ADDENDUM NO. 1

DATE: June 26, 2017  
TO: PROSPECTIVE BIDDERS  
FROM: MICHELLE CROWLEY LANDSCAPE ARCHITECTURE LLC  
281 SUMMER STREET FLOOR 6  
BOSTON, MA 02210

Project: Lafayette Park  
 Date: July 26, 2017

**SK-01**

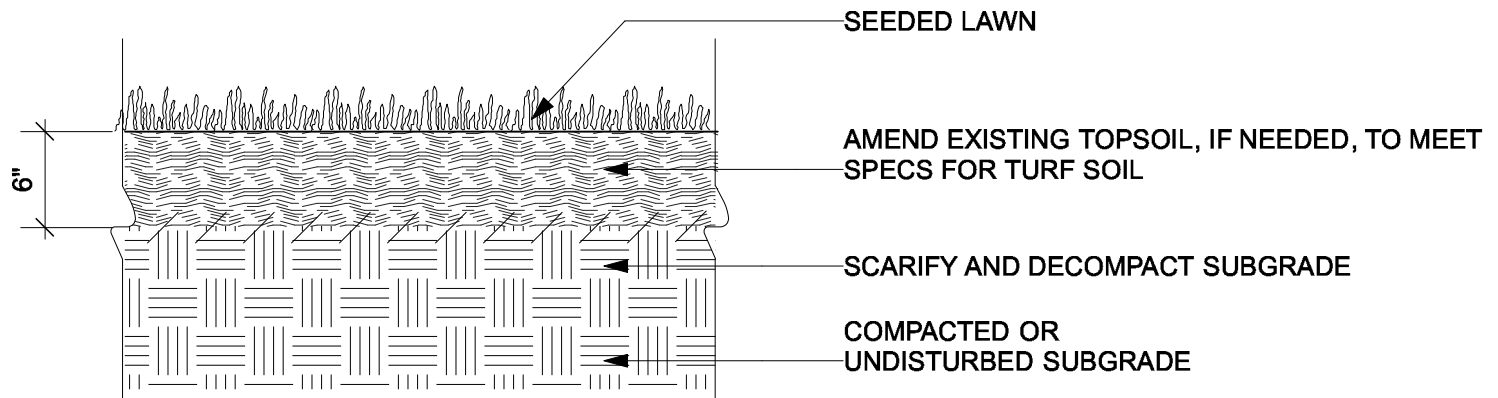
6. On drawing L4.0 PLANTING PLAN, PLANTING LEGEND, replace 'PL-LN Sod Lawn' with 'PL-LN Hydroseeded Lawn'. Contractor to provide price for hydroseeding lawn in all areas indicated on the drawings as part of the base bid. Add Alternate #2, Contractor to provide a price for sod lawn on the interior of the park only, lawn area located on the berm between the sidewalk and street to be seeded.
7. On drawing L4.0 PLANTING PLAN, PLANTING REFERENCE NOTES, replace #1 with- 'Provide sprinkler heads for all lawn and new trees on interior of park. Lawn and trees located on the berm between the sidewalk and street to have no permanent irrigation.'
8. Insert SK-1 Hydroseed Lawn Detail as part of the bid documents.
